TECHNICAL SERVICE BULLETIN 980530-008

TITLE:
REAR SQUEEGEE

APPLICABLE MACHINES:
530E

REAR SQUEEGEE LIFT CABLE AND BRACKET

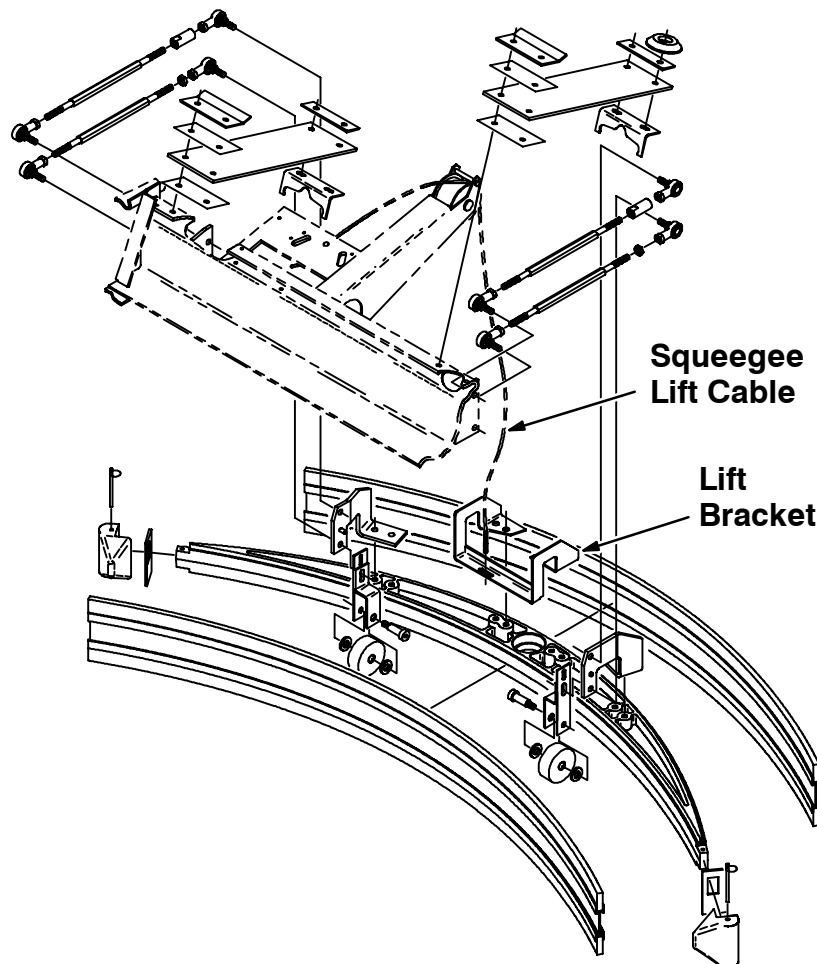
The squeegee lift cable, Tennant Company part number 86566, has been replaced by a new cable on machines with serial number 4000 and above. To replace the old cable order Tennant Company part number 12411. When replacing the old cable, the lift bracket 86871 should also be replaced.

REAR SQUEEGEE WHEEL SUPPORT

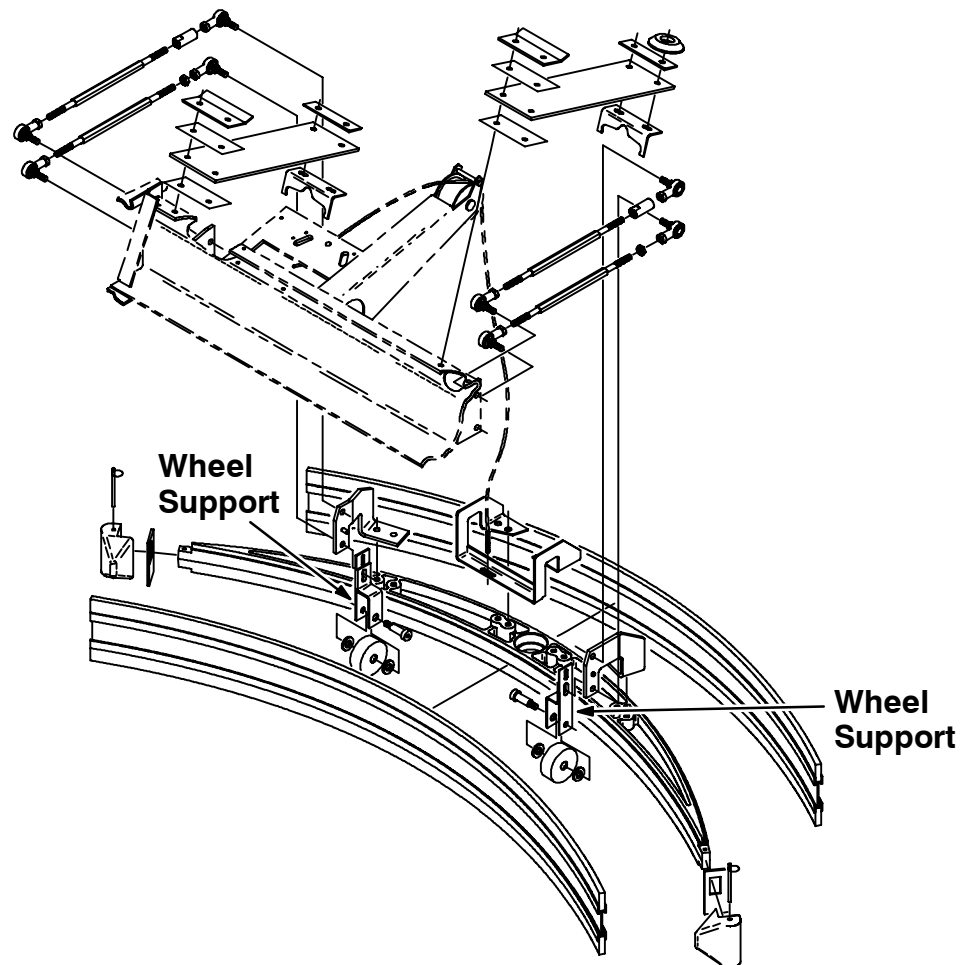
If the rear squeegee cannot be adjusted for the correct deflection, check the wheel supports. Proper adjustment of rear squeegee is not possible if either, or both of the wheel supports are bent. Wheel support, Tennant Company part number 86805, has been strengthened to prevent the chance of bending. The new wheel support is now in production.
